April 5, 2000
PY-CEI/NRR-2474L

Perry Nuclear Power Plant
Docket No. 50-440
License Amendment Request Pursuant to 10CFR50.90:
Activation of Thermal-Hydraulic Stability Monitoring Instrumentation

THERMAL POWER versus Core Flow
Figure 3.4.1-1

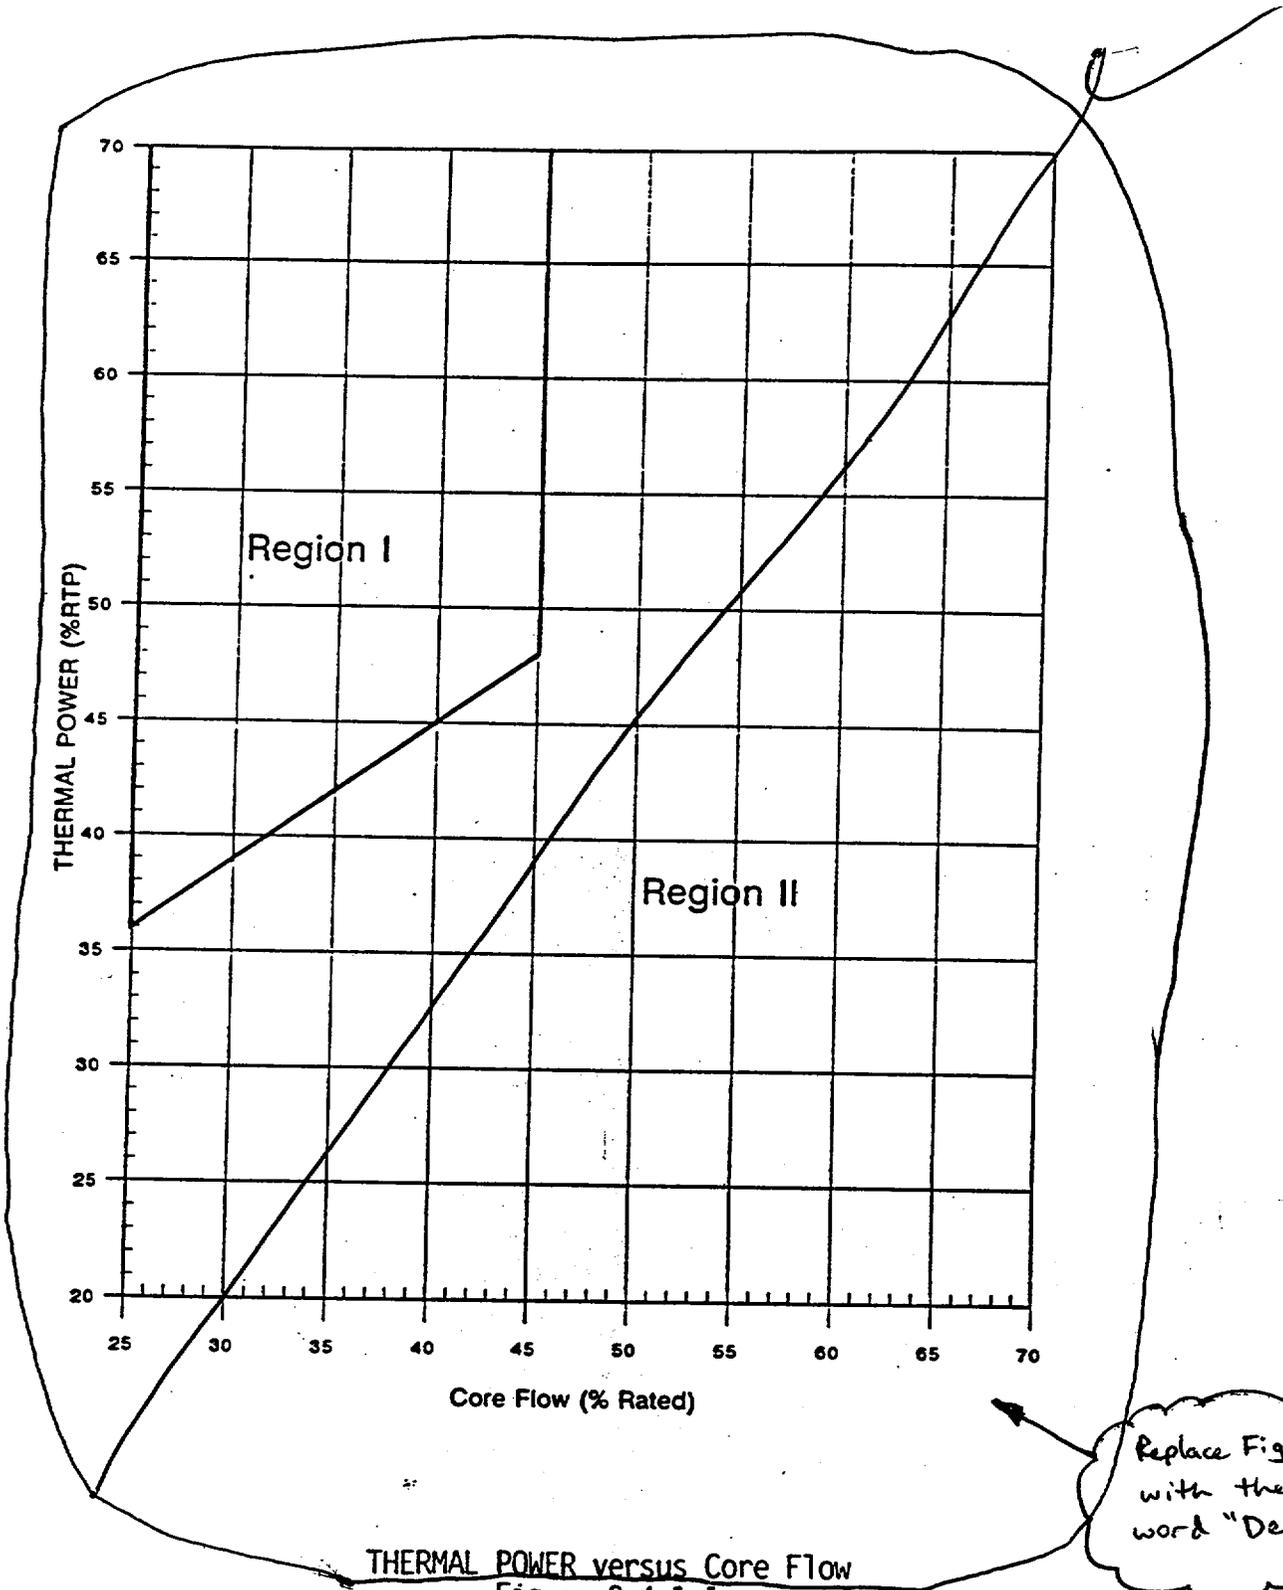
Replace Figure with the word "Deleted"
